Addendum Number 3

Lake Peachtree Spillway Replacement Project

August 4, 2017

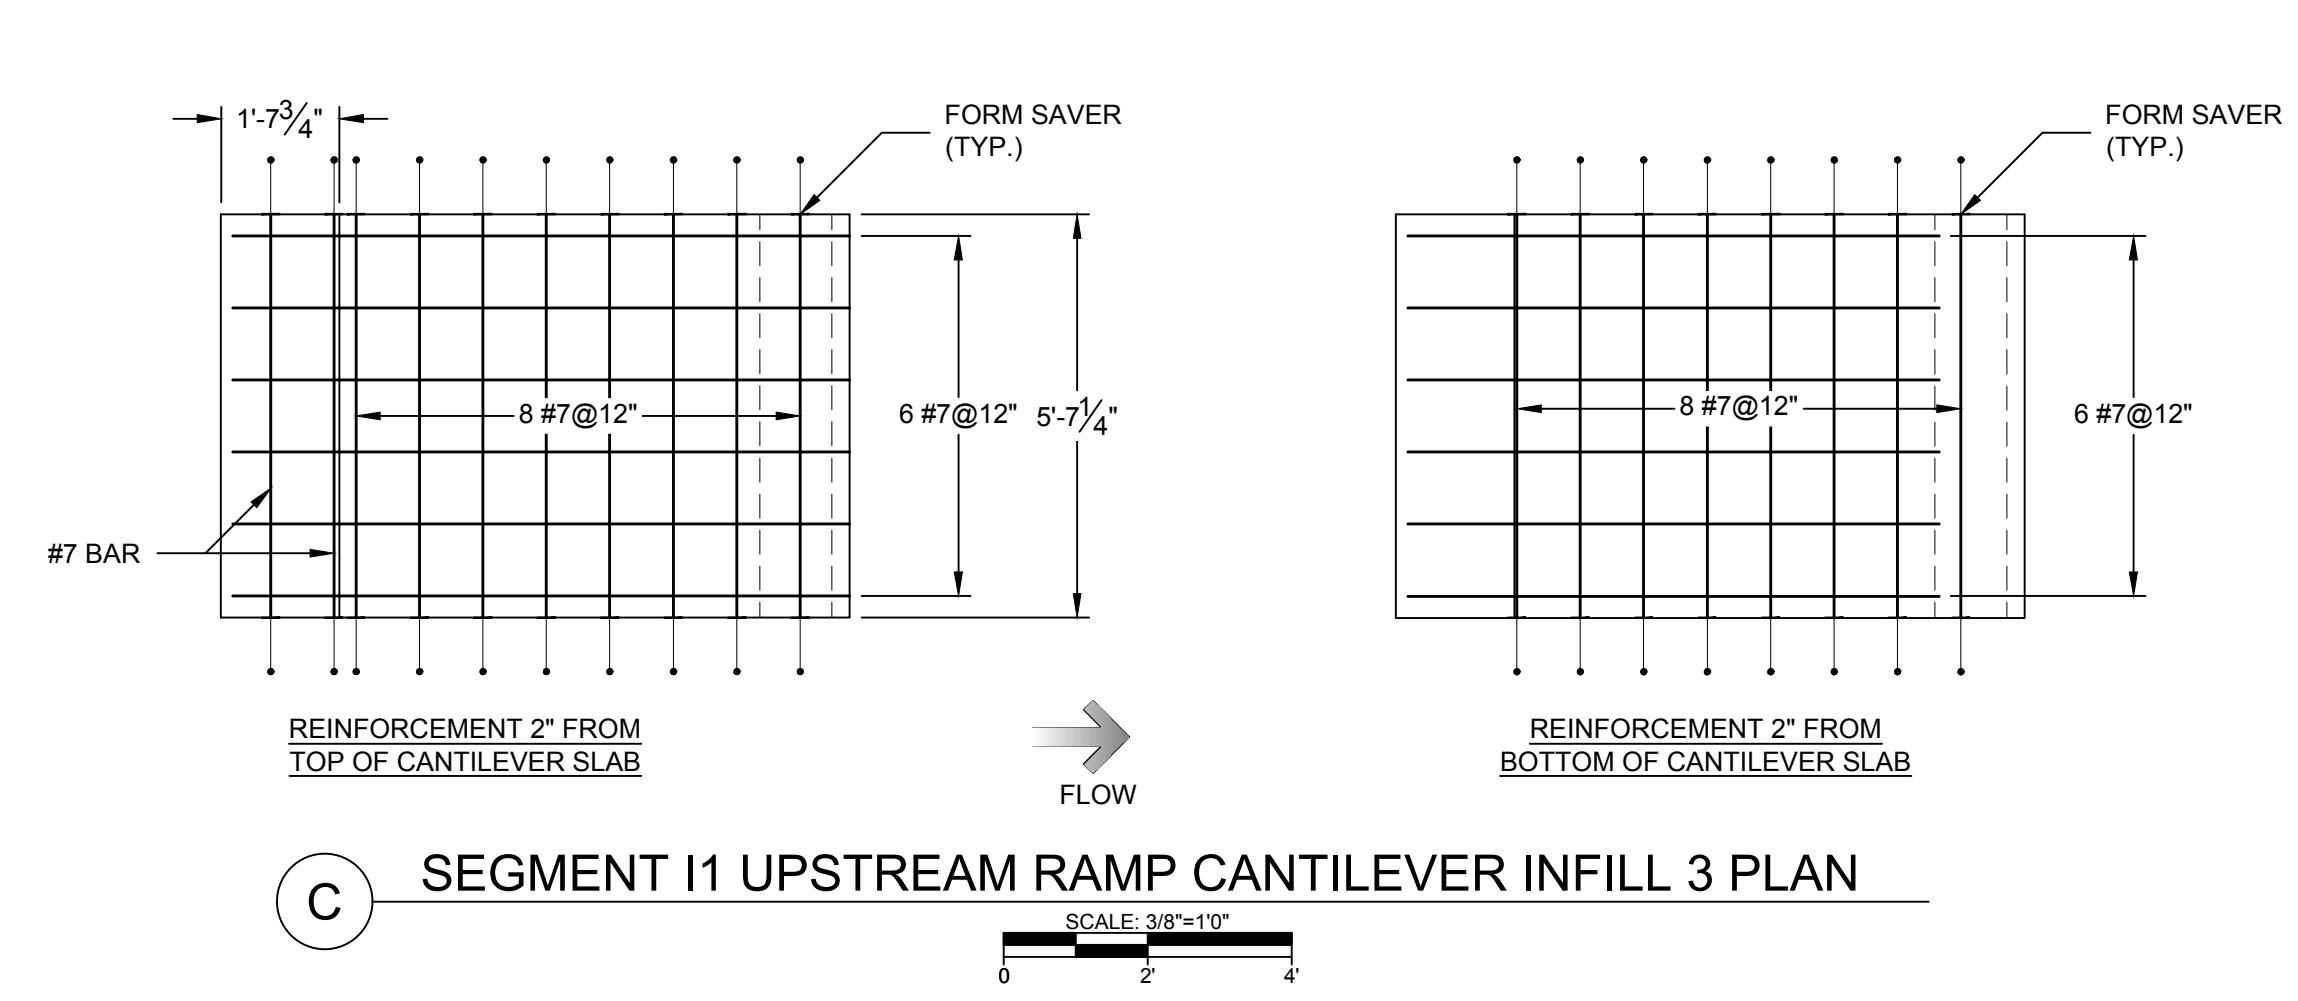
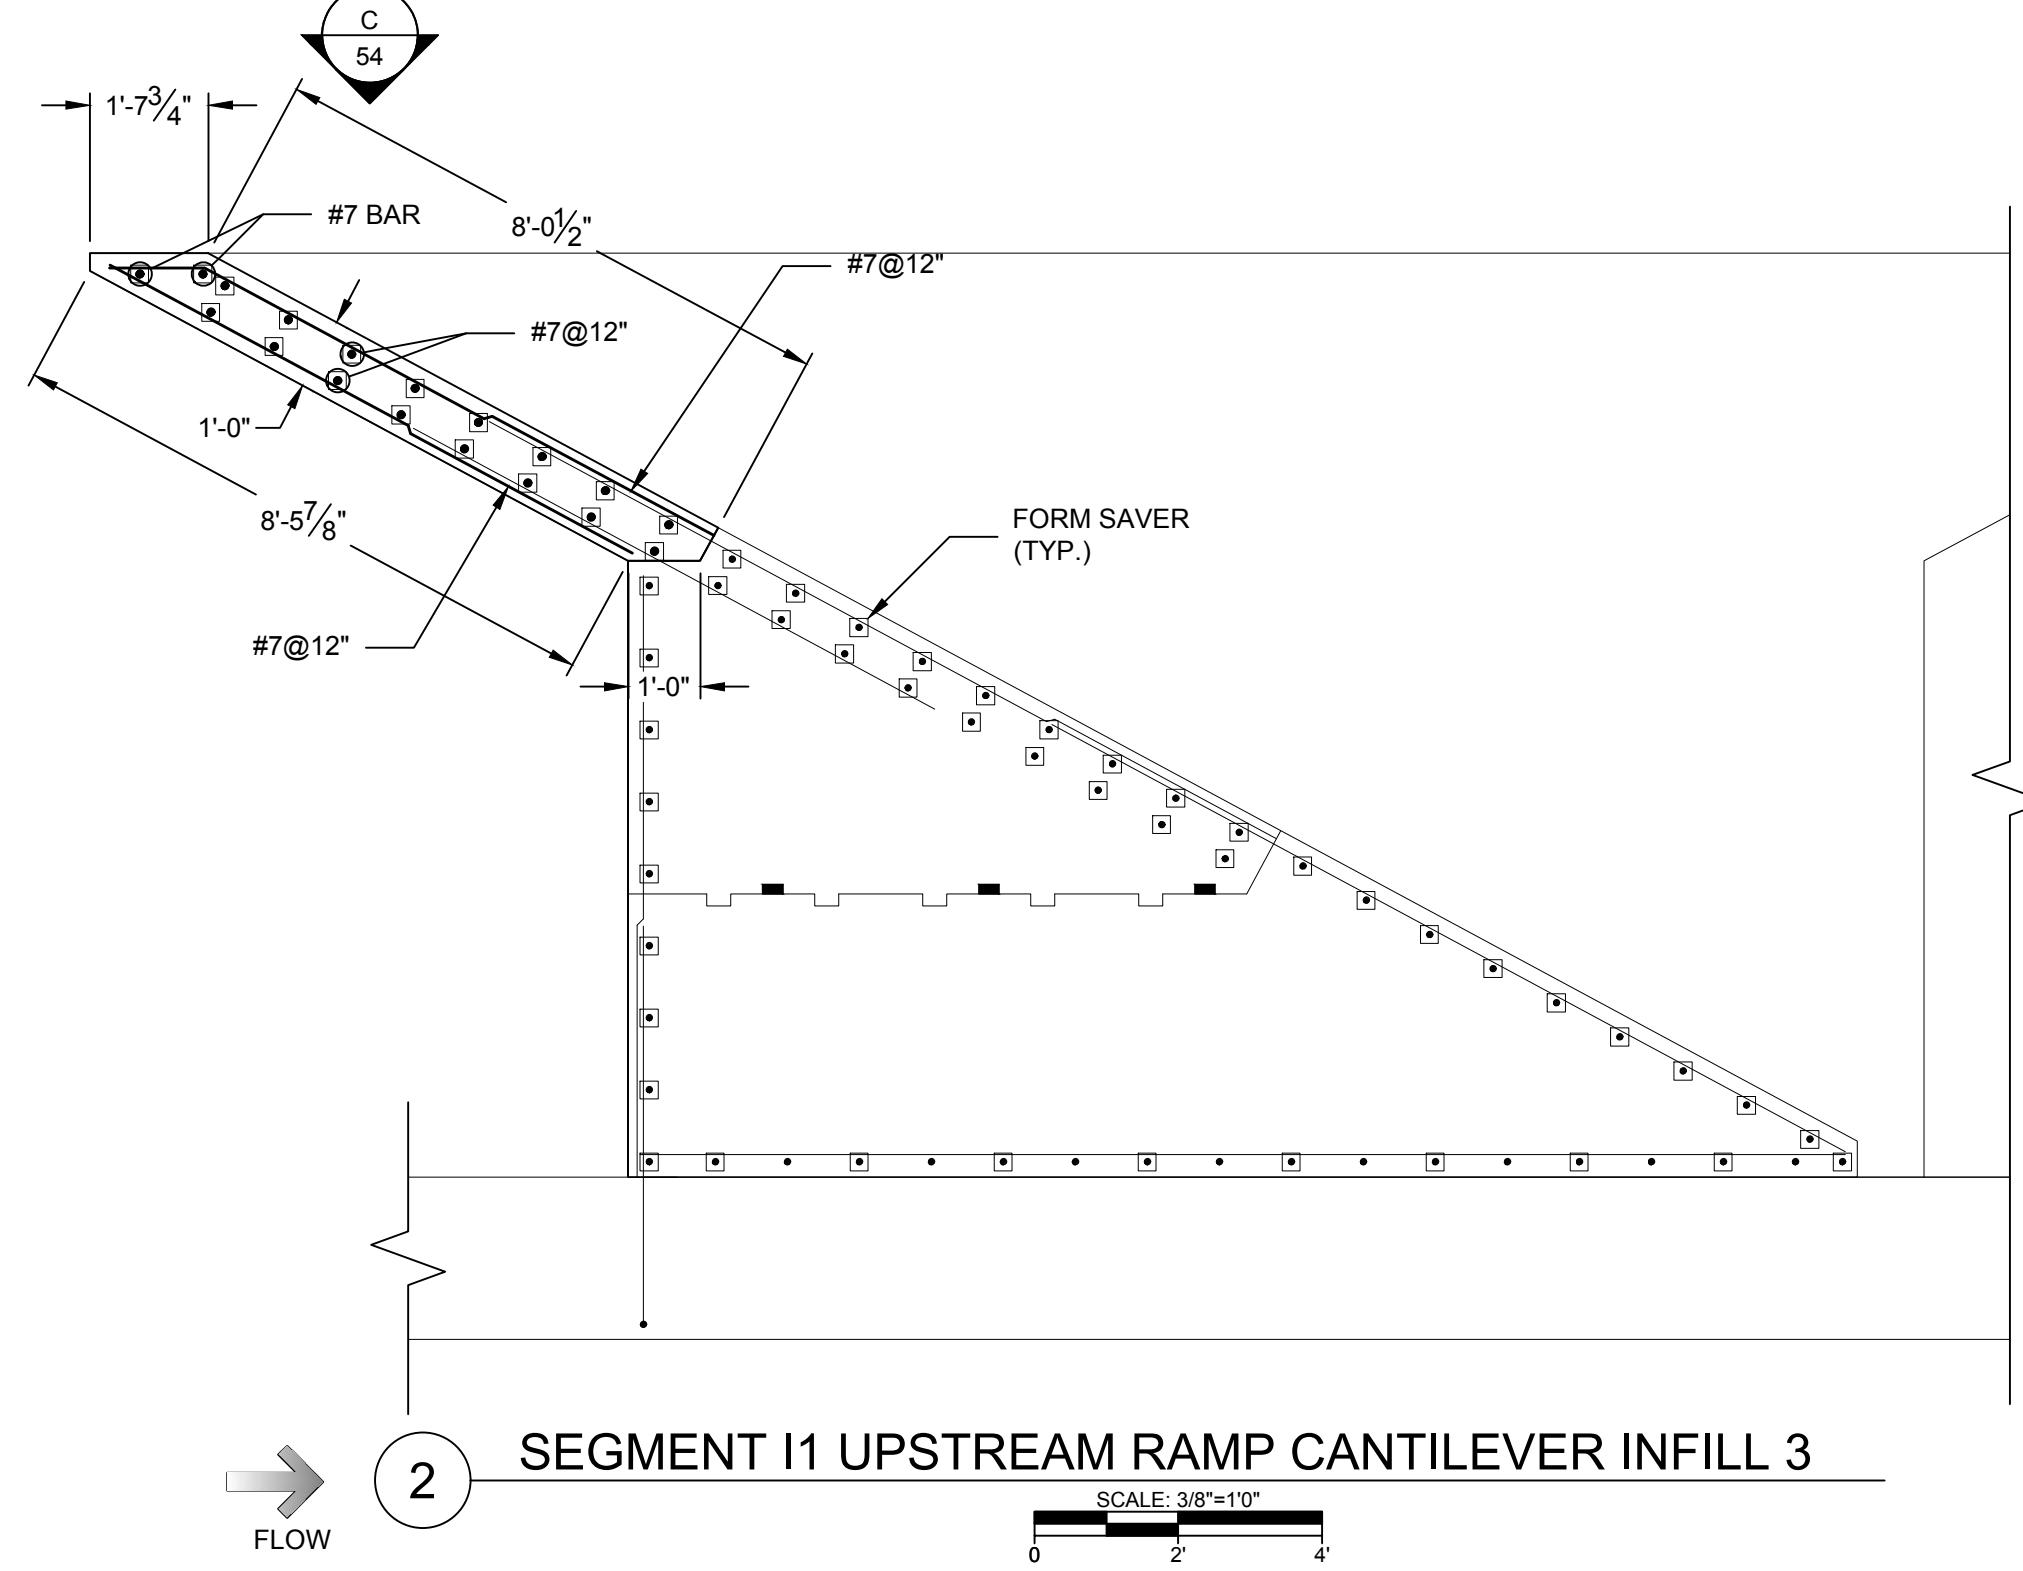
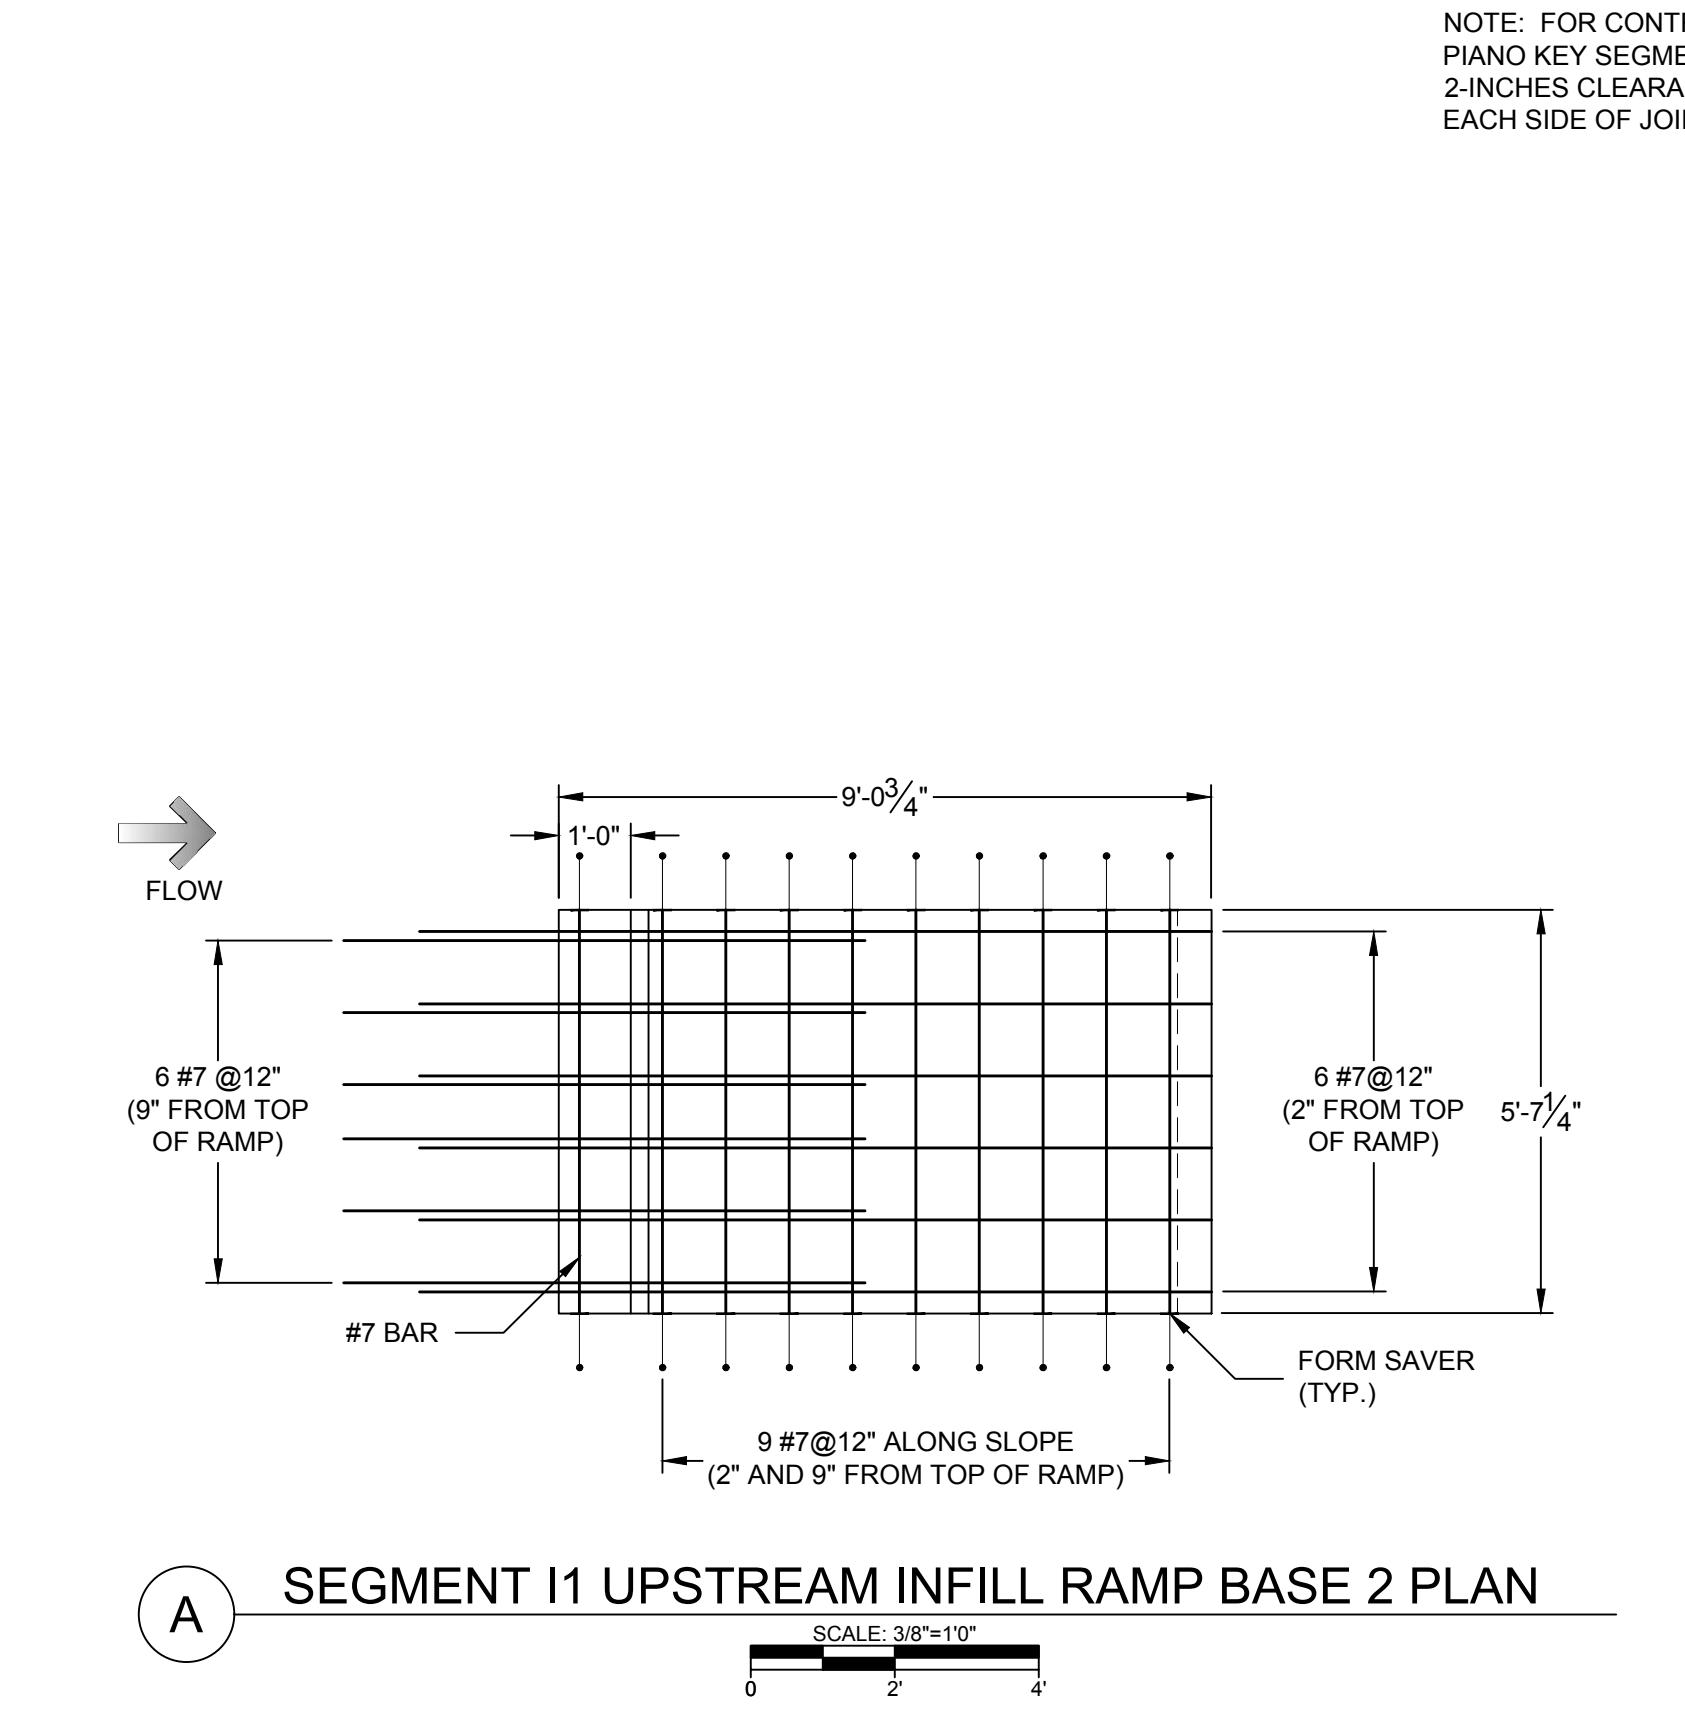
Note: The upstream ramp support walls (Sheets 37, 48, 53) were revised to include a 12-inch radius to improve hydraulic efficiency on the upstream ends of those walls.
